3. Stone Step Estates; KPB File 2024-125

ITEM #3 - PRELIMINARY PLAT
STONE STEP ESTATES

KPB File No.	2024-125
Plat Committee Meeting:	December 16, 2024
Applicant / Owner:	Moose Meadows LLC / Santa Barbara, CA
Surveyor:	Christopher Mullikin / Mullikin surveys LLC
General Location:	2 miles easterly of Kachemak limits and 1.5 miles east of East end Rd

STAFF REPORT

Alignment - (1) PROFILE

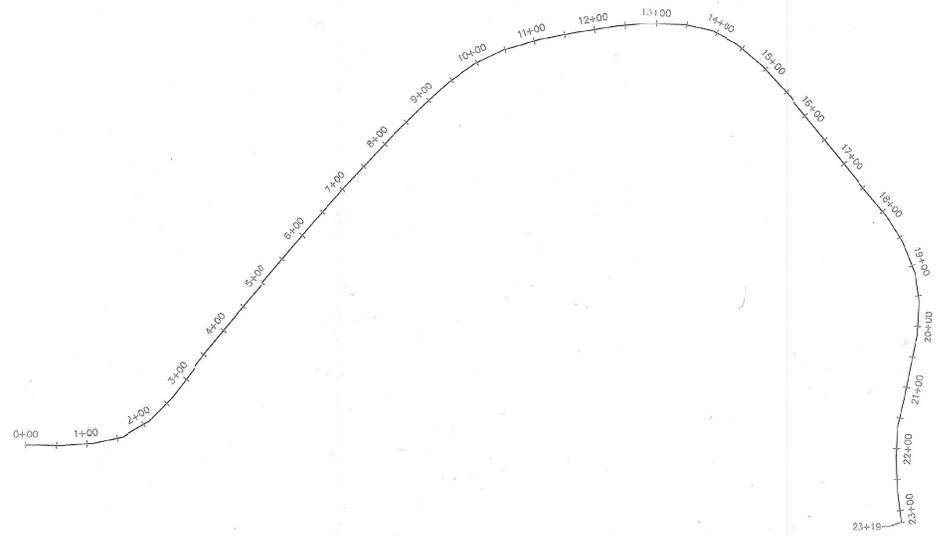
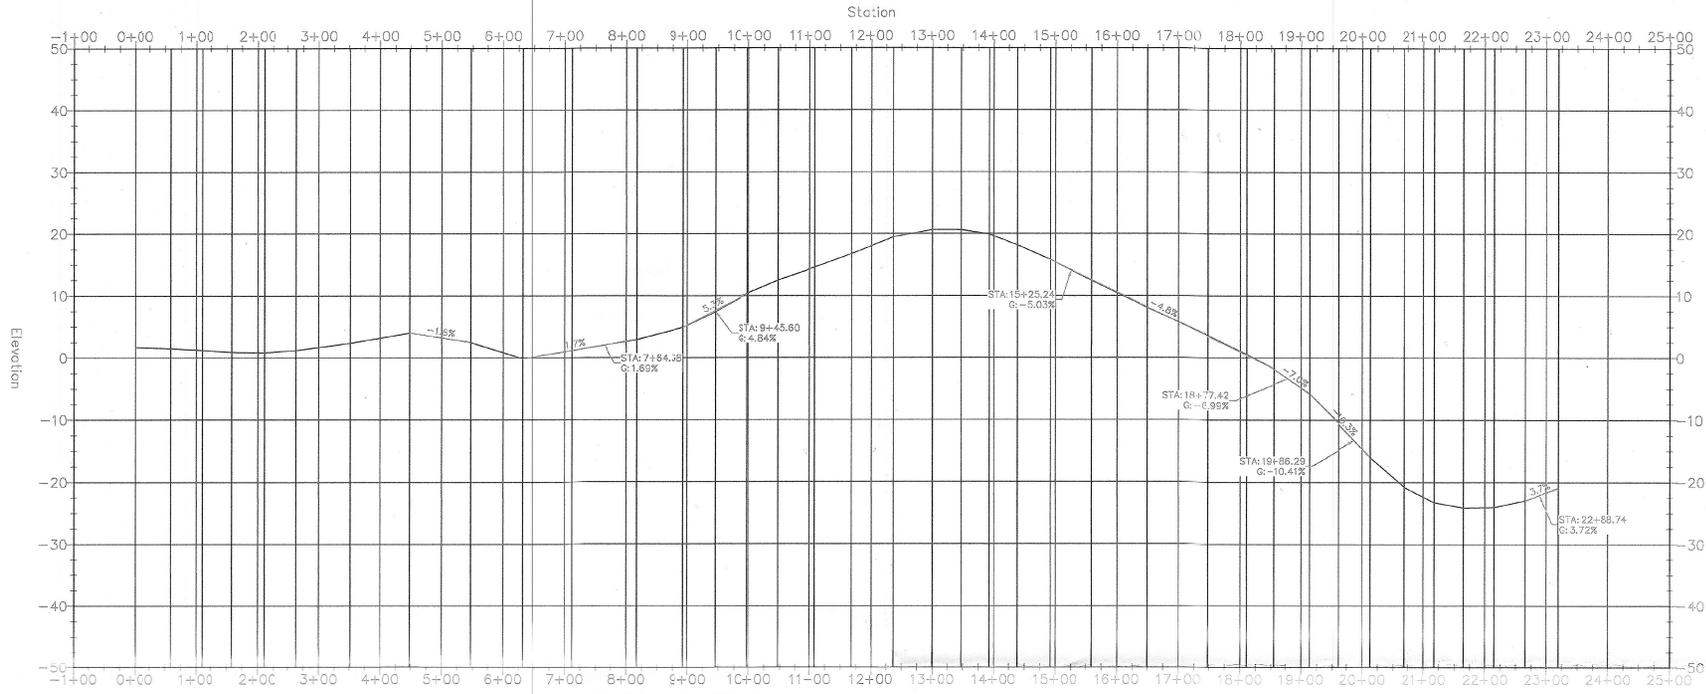
There are steep areas shown on the drawing by the hatched dots. Some of the area is near the end of the road before it crosses into the next plat south. A road profile was given to staff which was passed on the RSA Staff for review. RSA Staff had only issue with a portion near the end that had a 19 – 20% grade Platting is still waiting for a reply from RSA staff at this time. **Staff recommends** the surveyor comply with the suggestions if RSA has any to get the plat approved in the final submittal. Comments and recommendations will be passed on to the surveyor when received.

PRELIMINARY PLAT

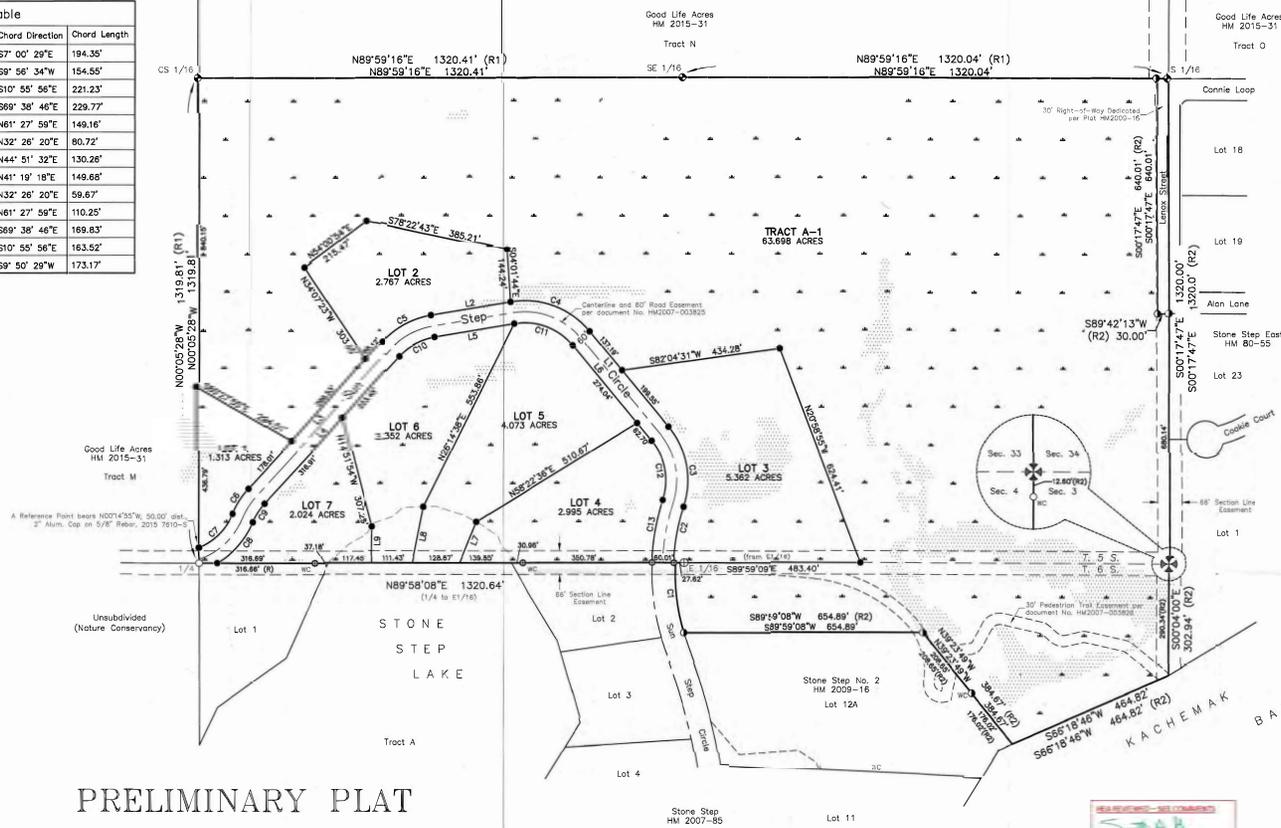
MEA requests that the front 10 feet of the building setback, and 20 feet within 5 feet of side lot lines, be granted as a utility easement.

Please provide a plat note to reference the utility easement as recorded under serial no. 2008-003001-0 Homer Recording District.
